Addendum No.3
to
CONSTRUCTION DOCUMENTS
for

NCISD New District Administration Building
21330 Valley Ranch Parkway
New Caney, TX. 77357
June 2, 2025

Below is a summary of the sheet and specification revisions for Addendum #3.

PLUMBING ENLARGED FLOOR PLAN

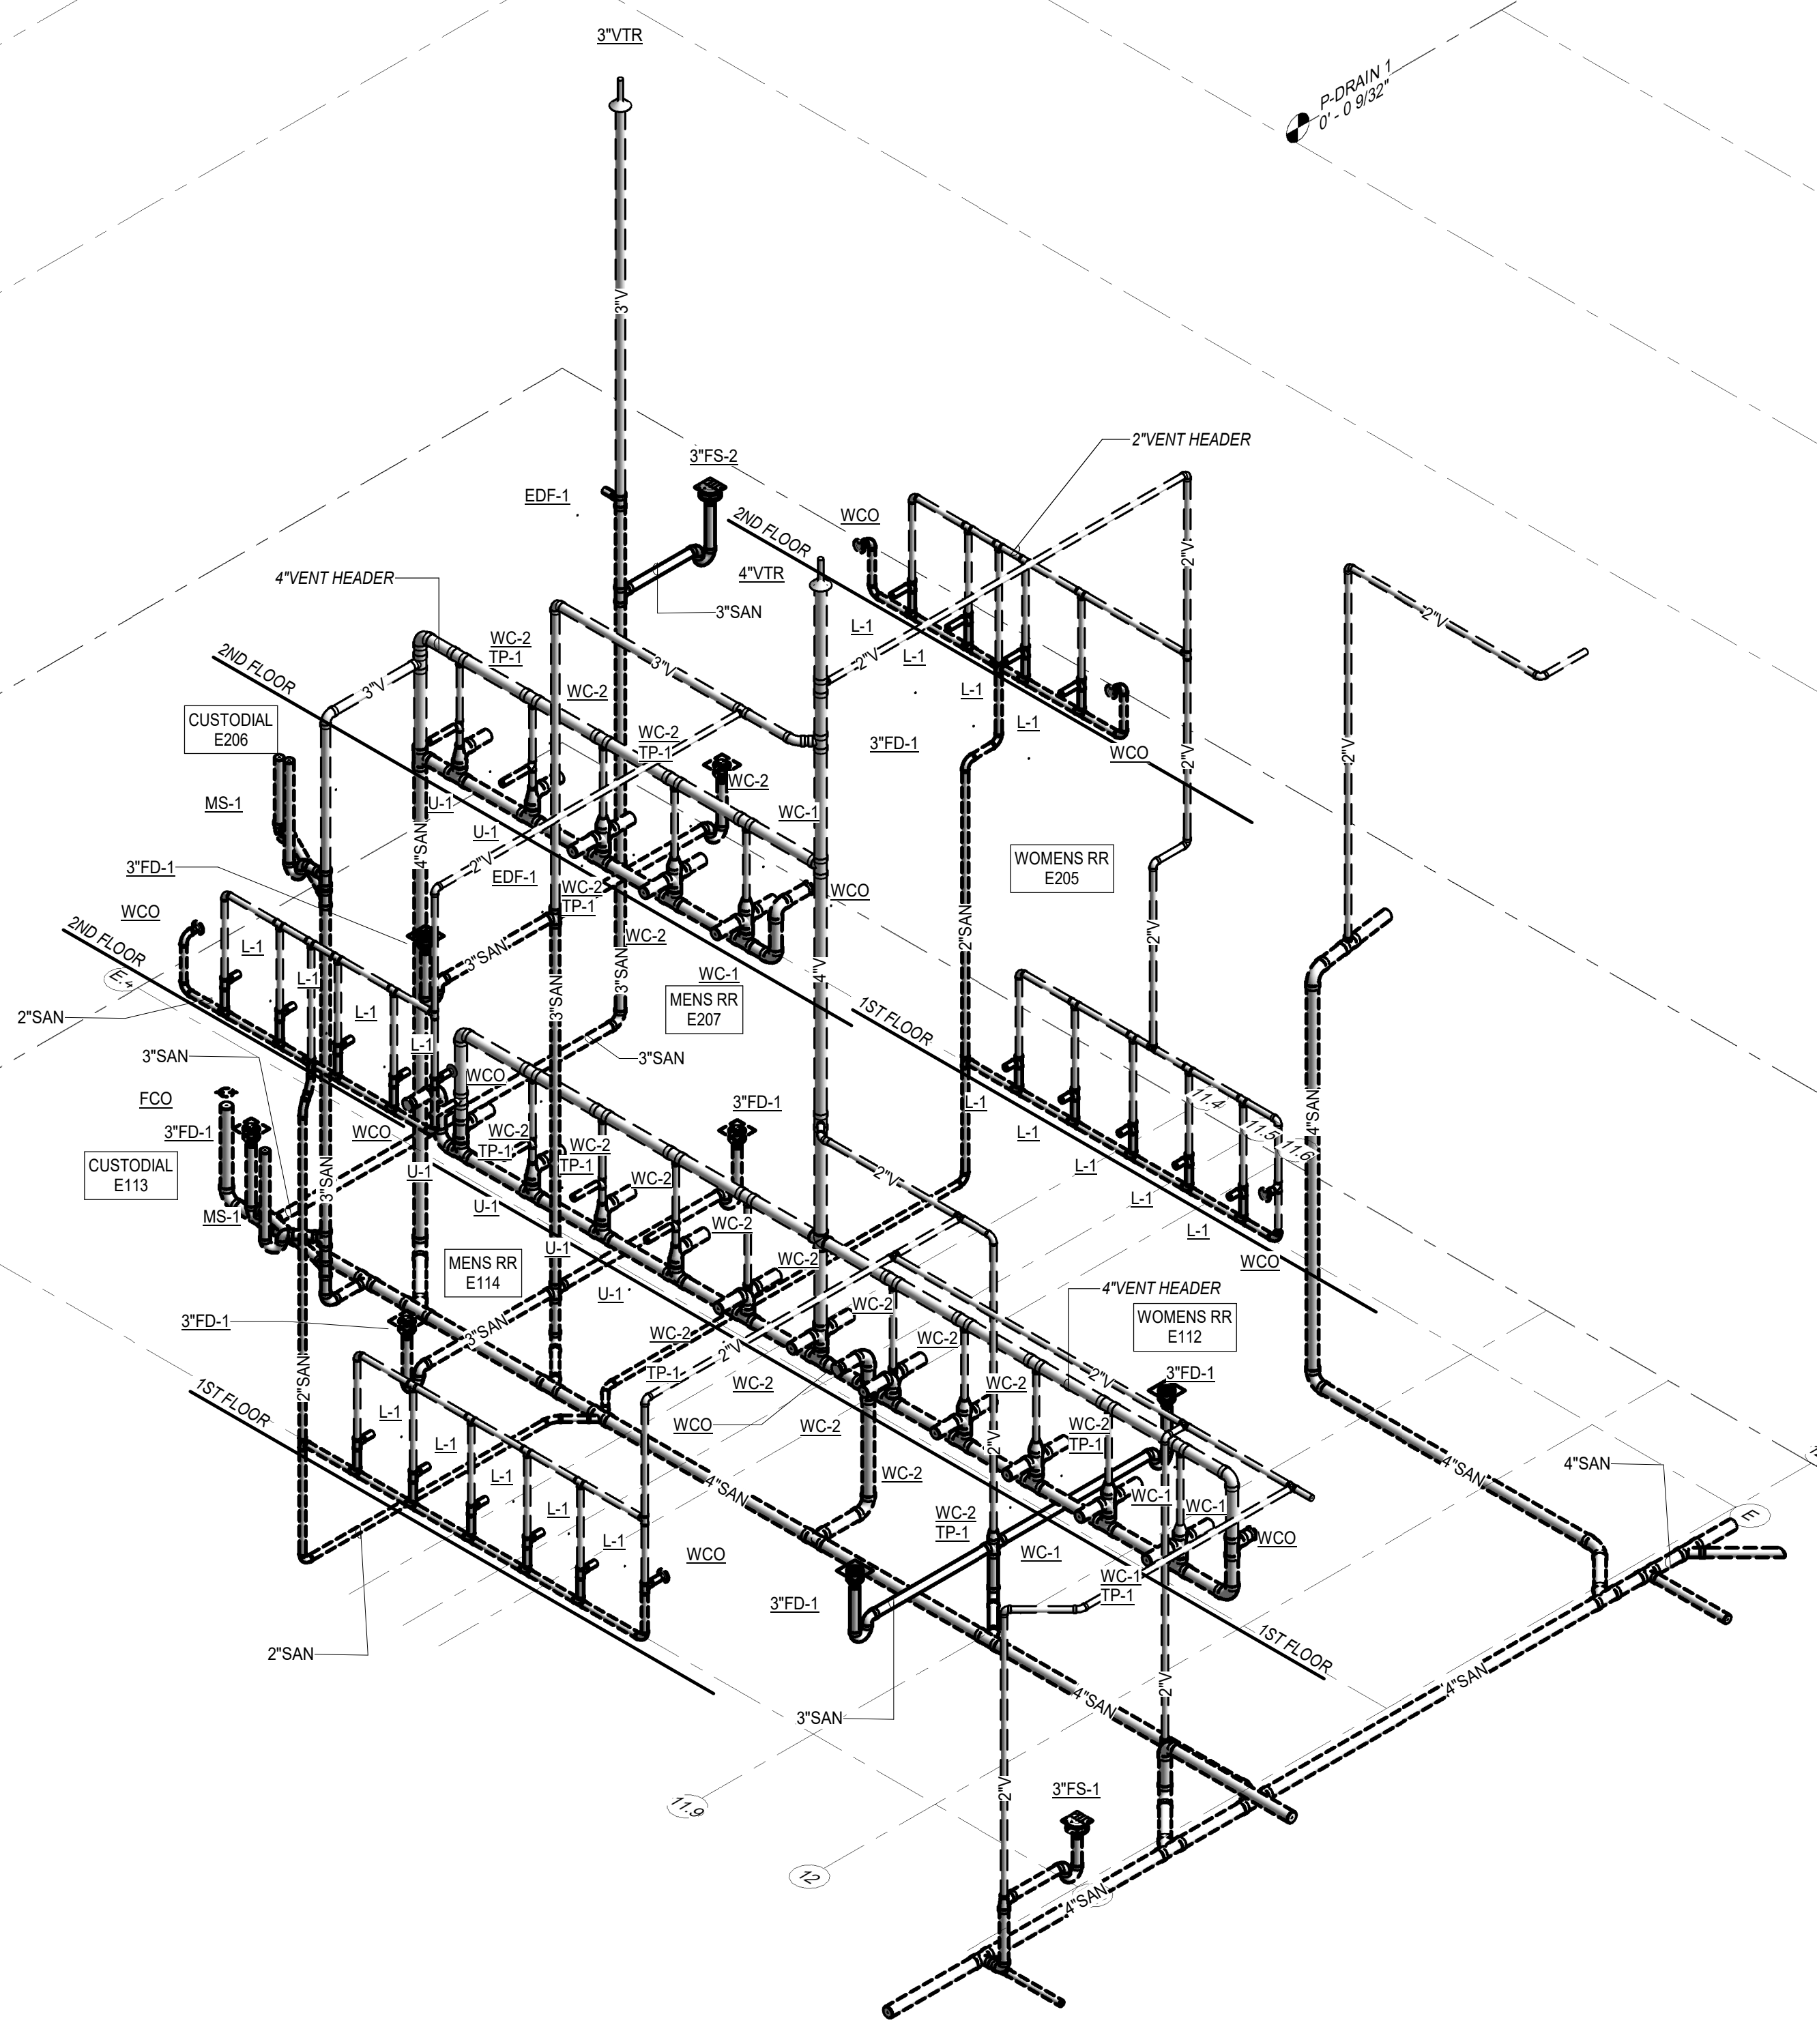
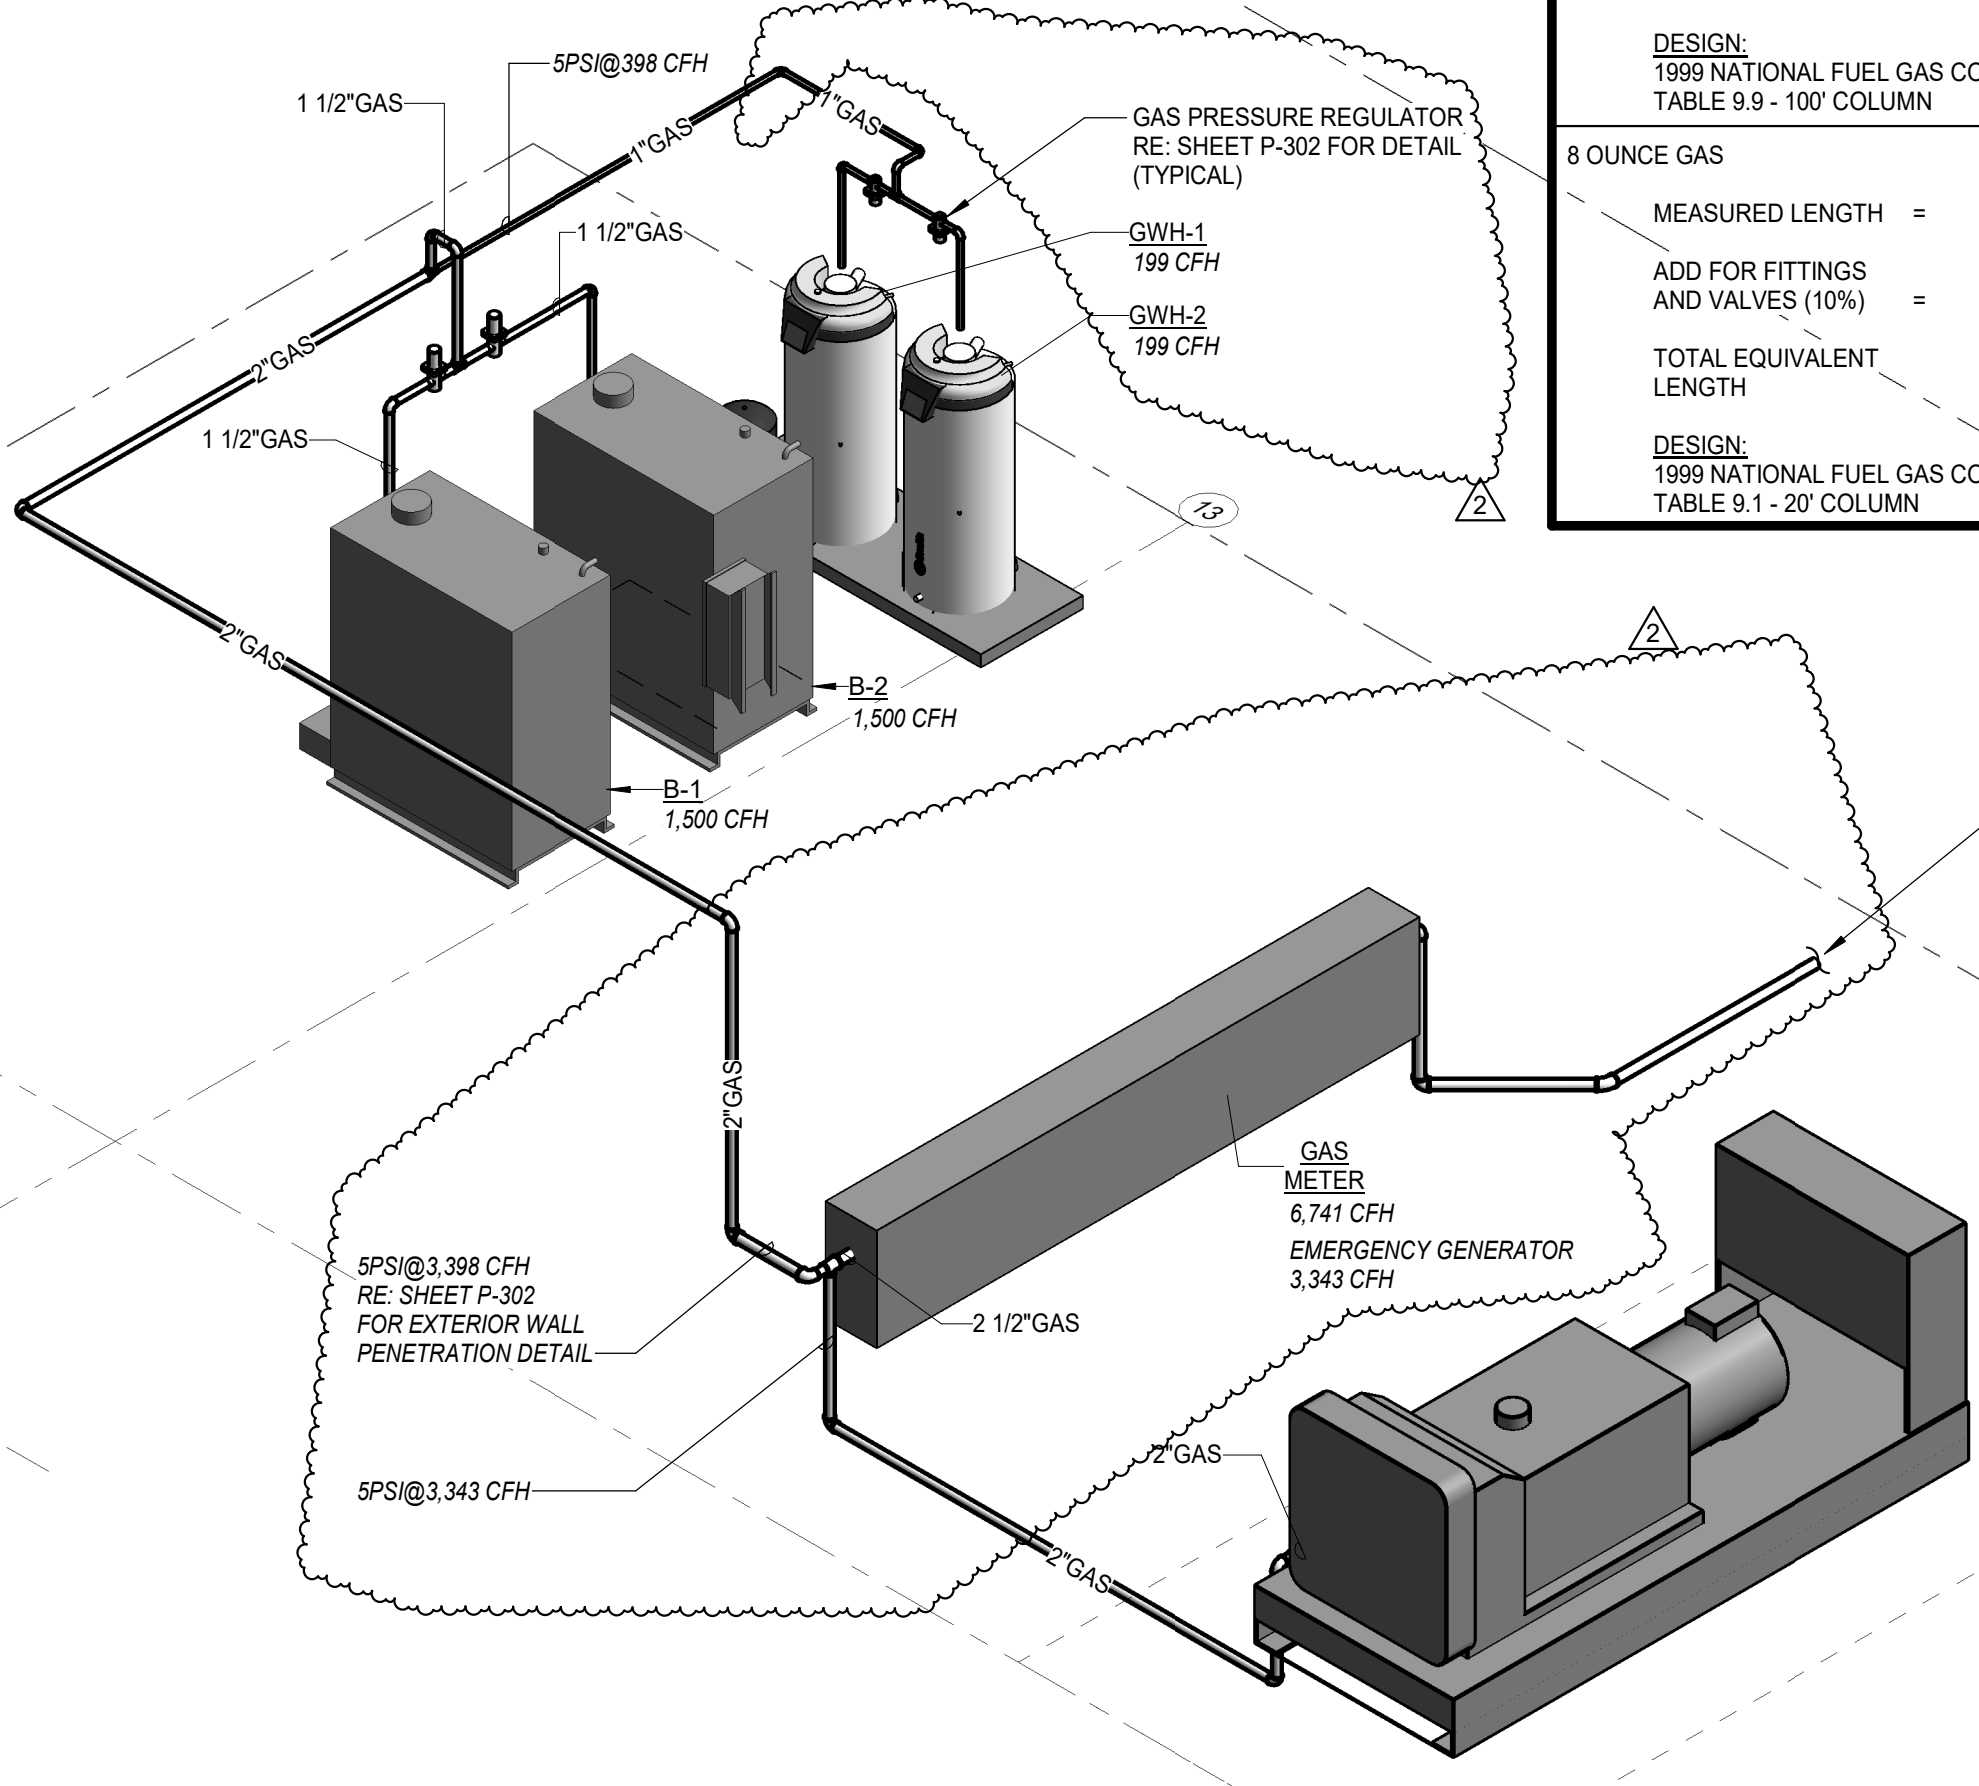
- a. Revise location of floor sinks serving units OAU-1 and AHU-4.
- 19. SHEET P-201 – PLUMBING ENLARGED FLOOR PLAN
 - a. Revise location of floor sink serving units OAU-2.
 - b. Revise gas meter location along with associated downstream gas piping.
- 20. SHEET P-501 PLUMBING RISER DIAGRAMS
 - a. VIEW #3 – GAS RISER DIAGRAM: Revise gas riser diagram reflecting new gas meter location and gas loads.
